Initial information on re-designed CL223 Loop cleat.

Re-design full size.

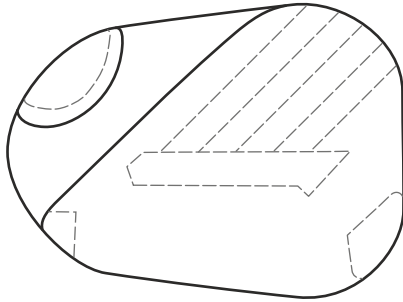
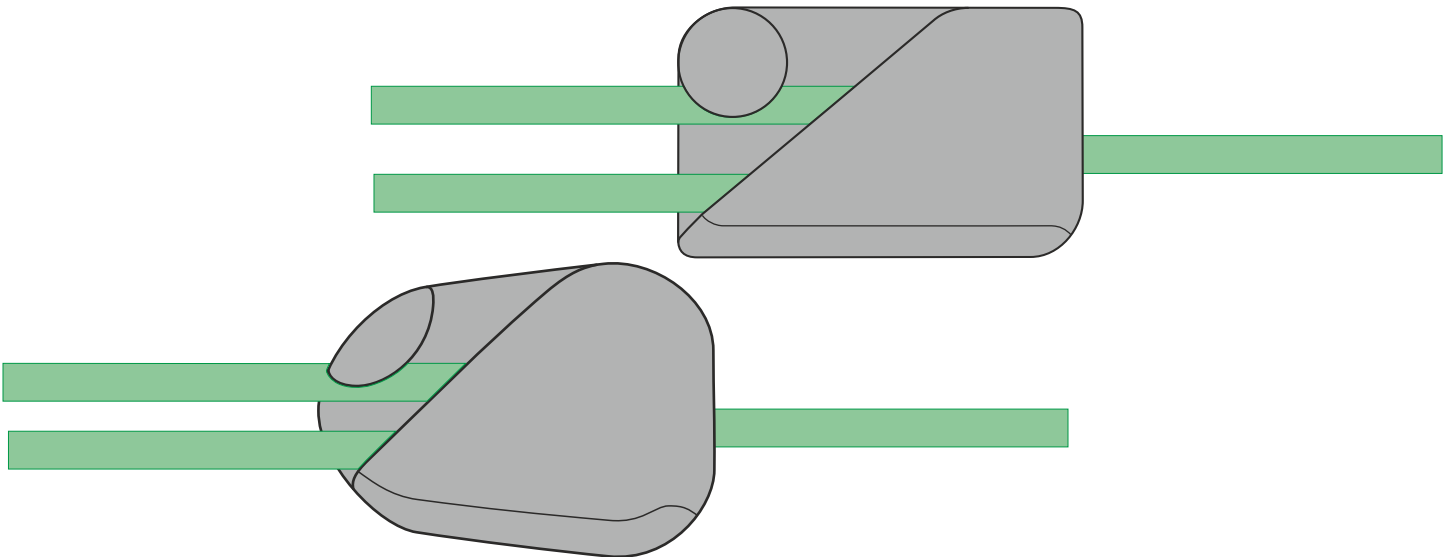
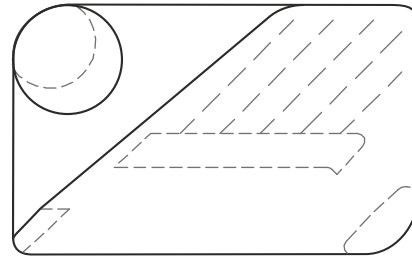
- Slightly shorter. Slightly higher. No heavier.
- More generous opening at the top of the teeth, so it is easier for the rope to go into the teeth.
- Strength of critical sections has been maintained or increased.
- All changes have been functionally and structurally tested.
- Deeper area for knot to disappear under the cleat.
- Hole sizes improved for easier rope threading.
- Sharp edges around front hole eliminated.
- Overall a more comfortable shape in your hand.
